Technical Support Service Alert

July 20, 2011

The intent of this Alert is to provide a quick reference to your service network on the motor component change for Red Jacket Submersible Turbine Pumps (STPs).

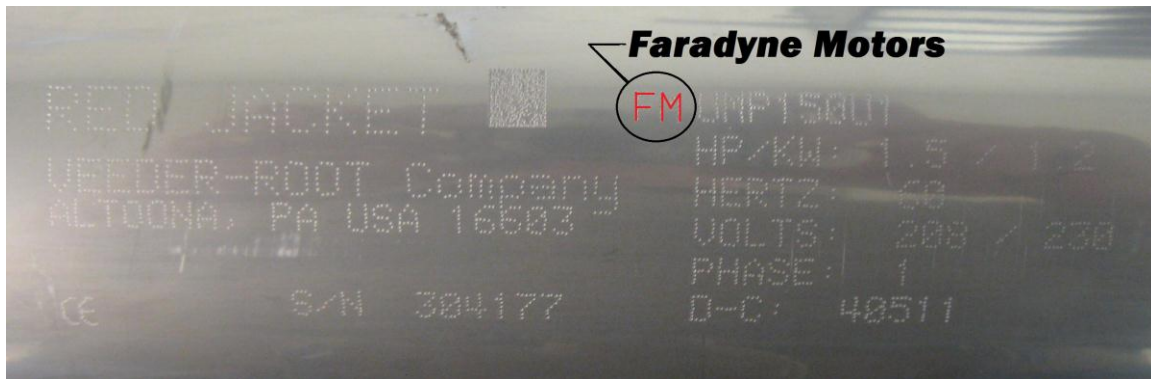
Effective August 1, 2011 Veeder-Root will begin shipping Submersible Turbine Pumps (STP) with motors from a new motor supplier, Faradyne Motors. This component change supports Veeder-Root's continued commitment to the industry to deliver reliable, safe, and high quality STPs. With the exception of the need to update IQ software to work with STPs with the new motor there are no backwards compatibility issues.

UMPs installed with a Faradyne motor can be identified based on stenciling on the UMP. See picture below:

Additionally, UMPs installed with a Faradyne motor can be identified based on slight differences in the end bell / discharge head. See comparison photos below:

Franklin Motor
Faradyne Motor
